Land at Oakley Farm, Cheltenham 24/00251/CONDIT

Friends of Oakley Farm
Pasture Slopes

The Friends of Oakley Farm Pasture Slopes – Response-2 to Planning Application 24/00251/CONDIT.

Fig 1. Main Access Road Vertical section

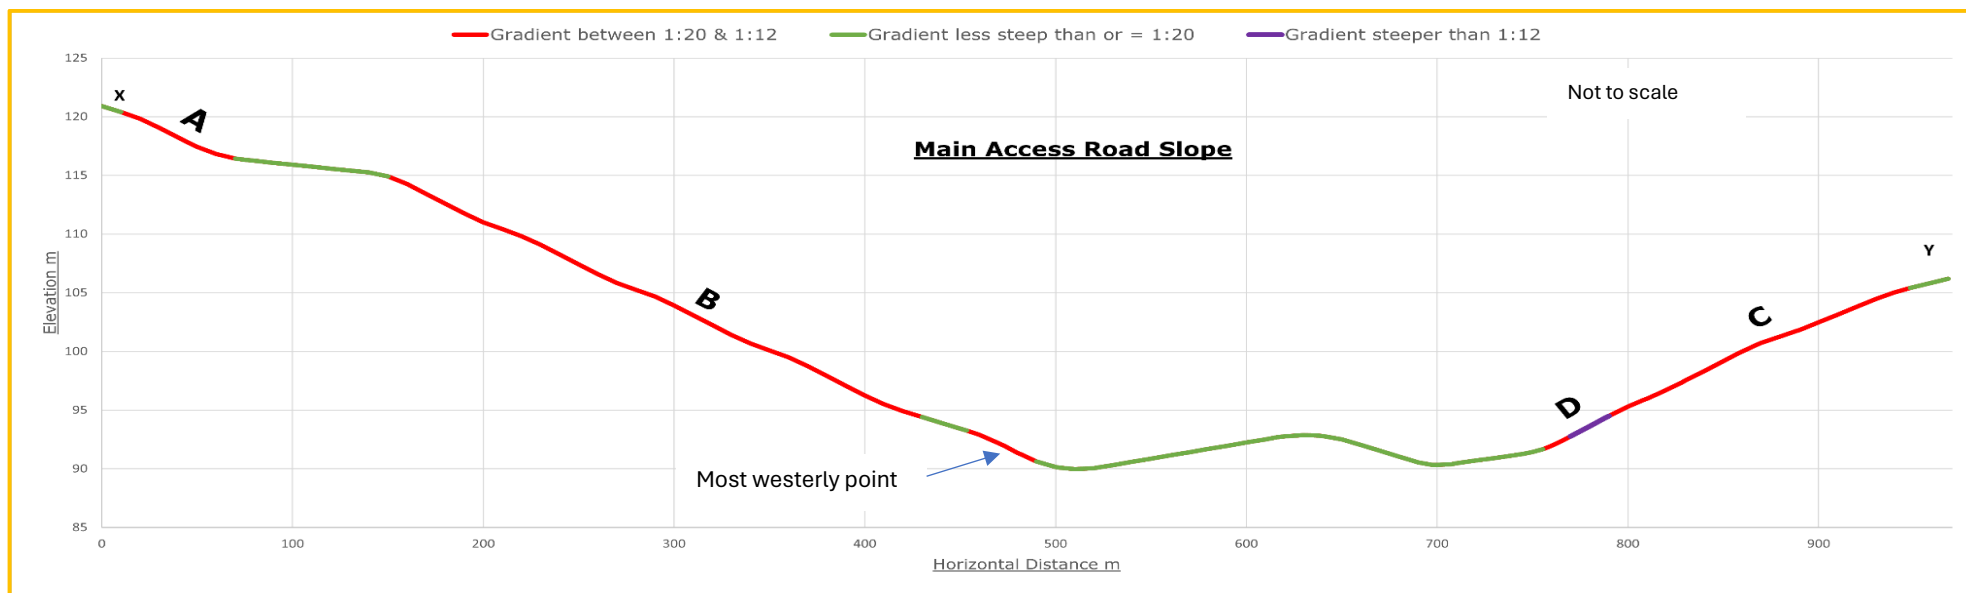
Figures 1 & 2 shown below, highlight 4 zones where the gradients are non-compliant with condition 13.

Zone A: Road section, 40m in length with an average gradient of 7.5% or 1:13.3

Zone B: Road section, 270m in length with an average gradient of 7.41% or 1:13.5

Zone C: Road section, 150m in length with an average gradient of 7.03% or 1:14

Zone D: Road section, 40m in length with a gradient of 8.33% or 1:12. Within the 40m section is a 24.5m length with a gradient of 8.62% or 1:11.6. Also, non-compliant with MfGS.

- Green sections represent road segments compliant with Condition 13.
- Red sections indicate road segments with gradients between 1:20 and 1:12, extending for more than 30m, thus non-compliant with Condition 13.
- Purple sections denote road segments where the gradient exceeds 1:12, also rendering them non-compliant with Condition 13 and MfGS

Approximately 56% of the road's total length surpasses the conditioned maximum gradient of 1:20, while 20% of the road features a gradient of 1:12.

Fig. 2. Main Access Road Horizontal layout.

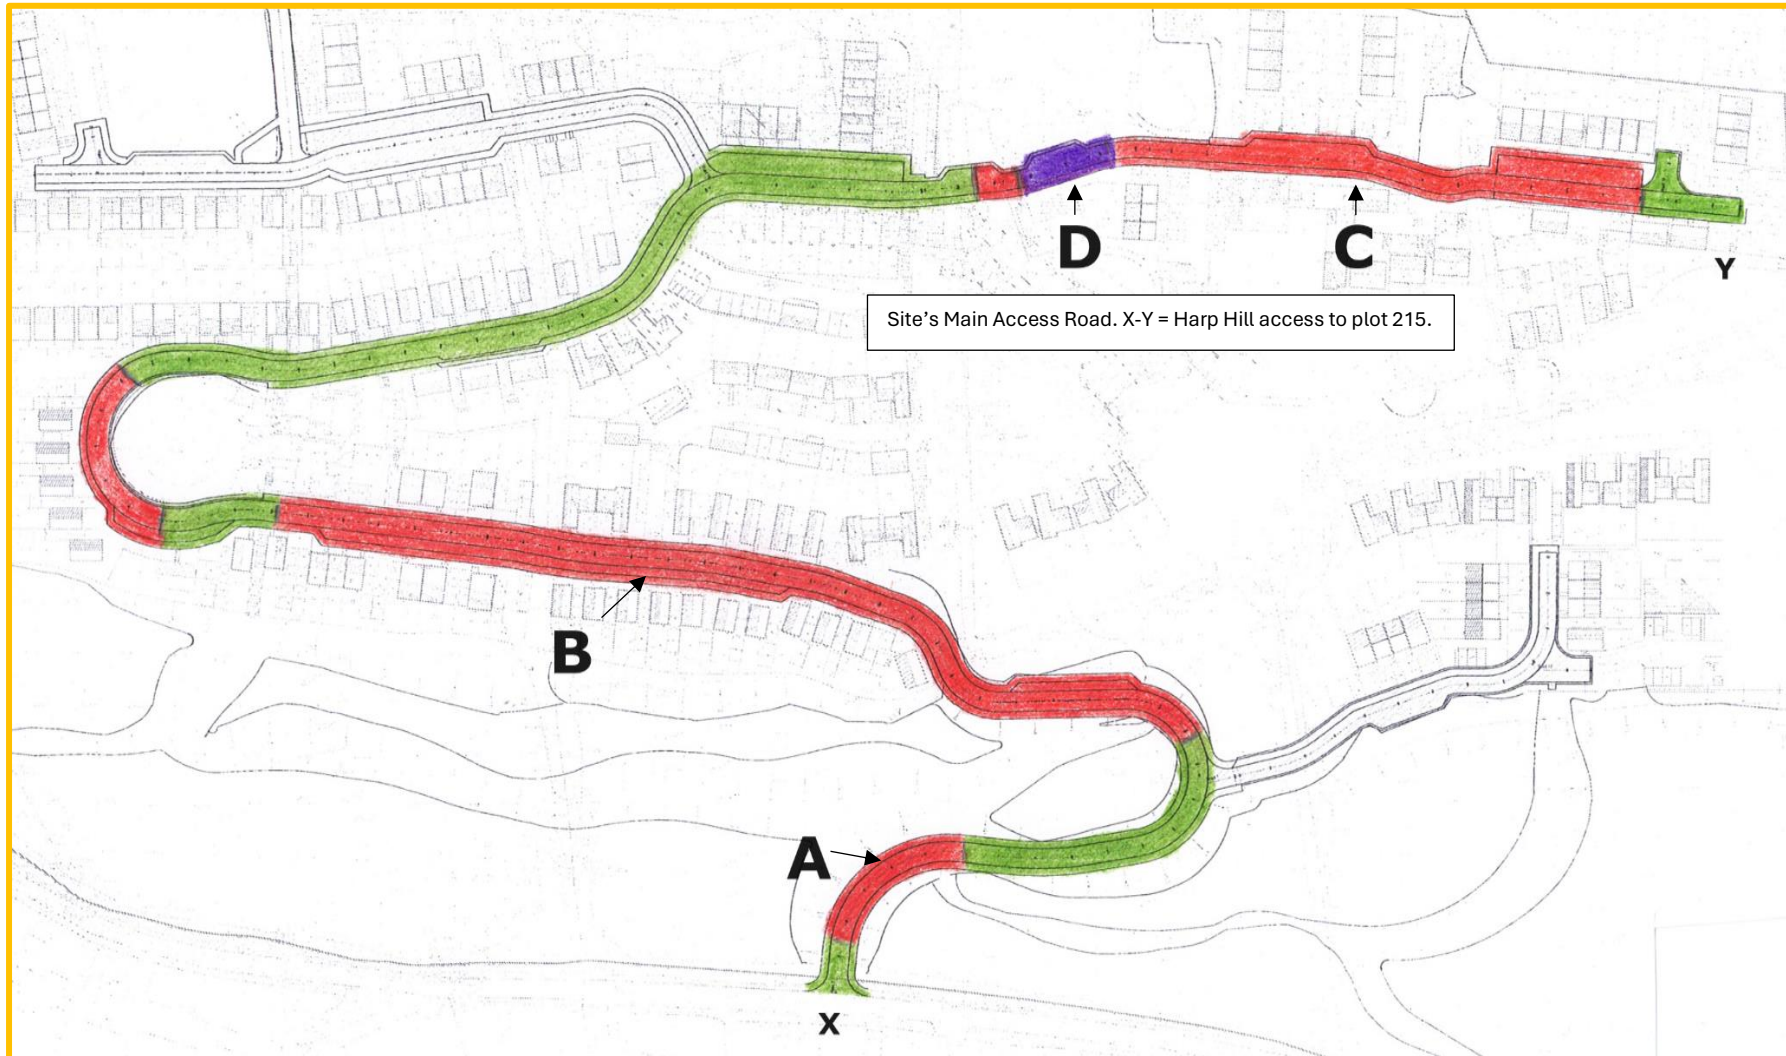
15. The gradients of the main access route are not in general accord with the maximum gradient of 1:20 as conditioned. They exceed this maximum for c56% of the total road's length. See figs. 1&2.

16. c20% of the main access road is proposed with gradients at the "ultimate maximum"² of 1:12. See figs. 1&2. Again, highlighting not in general accordance as conditioned.

Road divided into zones corresponding to those shown in as fig. 1

Fig. 3. Extract of “Zone D” detail from Applicant’s Longitudinal Section Drawing. Evidence of non-compliance with both Condition 13 and MfGS.

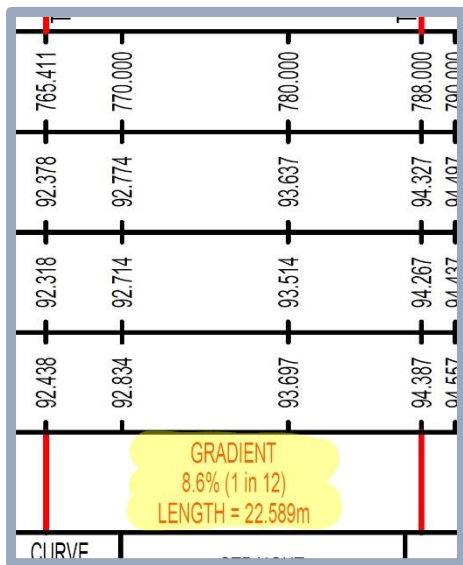
⁶ Between 765.411m and 790m a c25m section is shown as 8.6% this is equal to 1:11.6 and not the claimed 1:12. Exceeding the maximum gradient. See Fig. 3 below.

Taken from the applicant’s Access Strategy Longitudinal Sections diagram, this segment demonstrates further non-compliance with Condition 13. The depicted area corresponds to what we’ve identified as zone D. It presents a road section measuring 22.589 meters in length, featuring a gradient noted as 8.6% (1:12). However, when properly converted without rounding, 8.6% equates to 1:11.63. Zone D surpasses the prescribed 1:12 (8.33%) maximum stipulated by the condition. Furthermore, there’s an argument for the overall non-compliance of Zone D due to its total length of 40 meters at an average gradient of 8.33% or 1:12. Detailed figures for Zone D are outlined in Table 1 below. Notably, Zone D also fails to comply with the MfGS standards.

Gradient above should read: 8.6% (1:11.6)

Evidence of non-compliance with both Condition 13 and MfGS. Average gradient between 760m-800m of 8.33% (1:12) for 40m within which 25m at 8.6% (1:11.6).
